UNITED STATES PATENT AND TRADEMARK OFFICE

APPLICATION NO.	FILING DATE	FIRST NAMED INVENTOR	ATTORNEY DOCKET NO.	CONFIRMATION NO.
09/624,798	07/24/2000	Paul C Coffin	10001664-1	6517

Office Action Summary

DETAILED ACTION

Fig. 15, annotated, 1st configuration**Fig. 14, annotated, 2nd configuration**

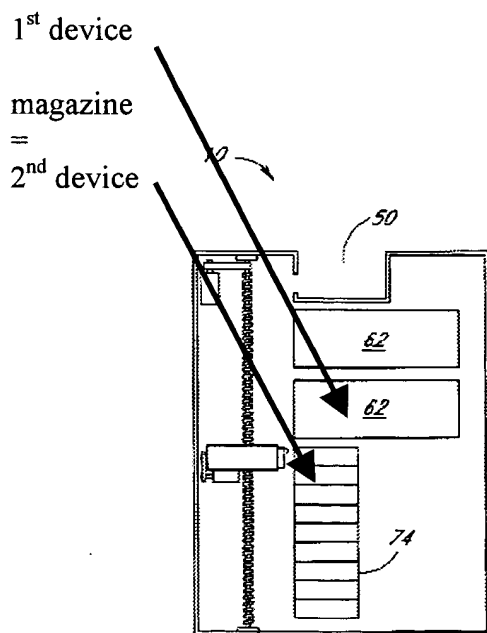
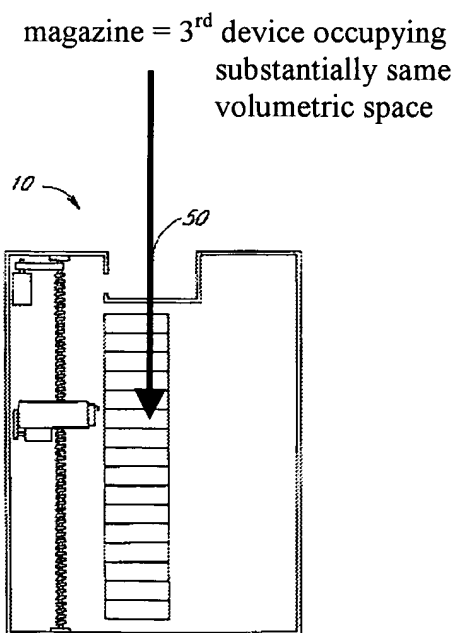
As recited in claims 1, 14 and 20, Menke et al show a reconfigurable cartridge processing module for use in a data storage system, comprising: a frame, said frame having a lower plate and an upper plate positioned in generally parallel, spaced-apart relation, said lower and upper plates of said frame having a plurality of sets of mounting locations provided thereon so that said frame defines a first component configuration (see Fig. 15) and a second component configuration (see Fig. 14), the first component configuration comprising: a first cartridge receiving device 5 mounted to a first set of the plurality of sets of mounting locations provided on said frame so that said first cartridge receiving device is located at a first position within said frame; and a second cartridge receiving device 5 mounted to a second set of the plurality of sets of mounting locations provided on said frame so that said second cartridge receiving device is located at a second position within said frame, said first and second cartridge receiving devices together occupying a volumetric space within said frame, wherein said first and second cartridge receiving devices are located substantially between the upper and lower plates of said frame when said frame is in the first component configuration; the second component configuration comprising a third cartridge receiving device 4 mounted to a third set of the plurality of sets of mounting locations provided on said frame, said third cartridge receiving device occupying substantially the same volumetric space within said frame as is occupied by said first and second cartridge receiving devices in said first component configuration (see annotated Figs. 14-15),

wherein said third cartridge receiving device is located substantially between the upper and lower plates of said frame when said frame is in the second component configuration.

The above is only one example of many possible interpretations of the reference which satisfy the claim language. Alternatively, Fig. 14 may be interpreted as the first configuration with Fig. 13 as the second configuration.

As recited in claims 5 and 15, Menke et al show that the second position is located adjacent the first position so that said second cartridge receiving device is located adjacent said first cartridge receiving device when said frame is in the first component configuration (see positions of 1st receiving device and 2nd receiving device in Fig. 15 annotated above).

As recited in claim 17, Menke et al show that said first cartridge receiving means comprises cartridge read/write means 5 for reading data from and writing data to said at least one data cartridge 7.

Kersey et al Fig. 4b (annotated)**= first configuration****Kersey et al Fig. 4c (annotated)****= second configuration**

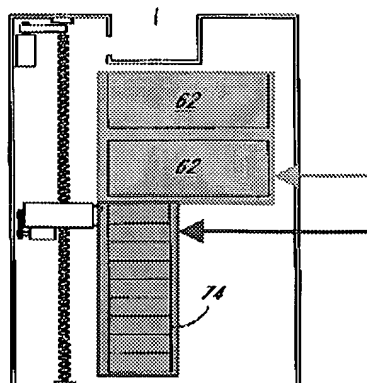
As recited in claims 1, 3, 5-6, 10, 12, 14-18 and 20, insofar as they are understood in view of the indefiniteness rejections, Kersey et al show a reconfigurable cartridge processing module (see teachings in paper no. 5 and arguments below).

As recited in claims 3, 12 and 18, Kersey et al show that said second cartridge receiving device 74 comprises a cartridge storage magazine.

As recited in claims 5 and 15, Kersey et al show that the second position is located adjacent the first position so that said second cartridge receiving device 74 is located adjacent (see Fig. 5) said first cartridge receiving device 62 when said frame is in the first component configuration.

Kersey et al Fig. 4b (annotated)**= first configuration**

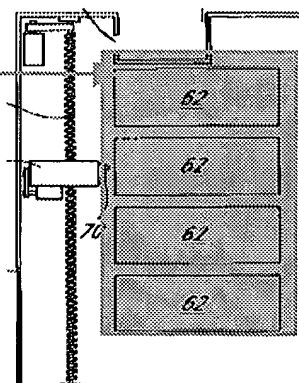
As recited in claims 6 and 16, Kersey et al show that the second position is located alongside the first position so that said second cartridge receiving device 74 is located alongside (see Fig. 5) said first cartridge receiving device 62 when said frame is in the first component configuration.

As recited in claim 17, Kersey et al show that said first cartridge receiving means comprises cartridge read/write means 62 for reading data from and writing data to said at least one data cartridge.

As recited in claims 2 and 11, Kersey et al show that said first cartridge receiving device (drives 62 and 62 taken together) comprises a half-width cartridge read/write device (said device is half-width insofar as it occupies substantially half the width of the frame; see Fig. 5).

As recited in claims 4 and 13, Kersey et al show that said third cartridge receiving device (drives 62 and 62 and 62 and 62 taken together) comprises a full-width cartridge read/write device (said device is full-width insofar as it occupies substantially the full width of the frame).

As recited in claim 19, Kersey et al show that said third cartridge receiving means (drives 62 and 62 and 62 and 62 taken together) comprises cartridge read/write means 62 for reading data from and writing data to said at least one data cartridge.
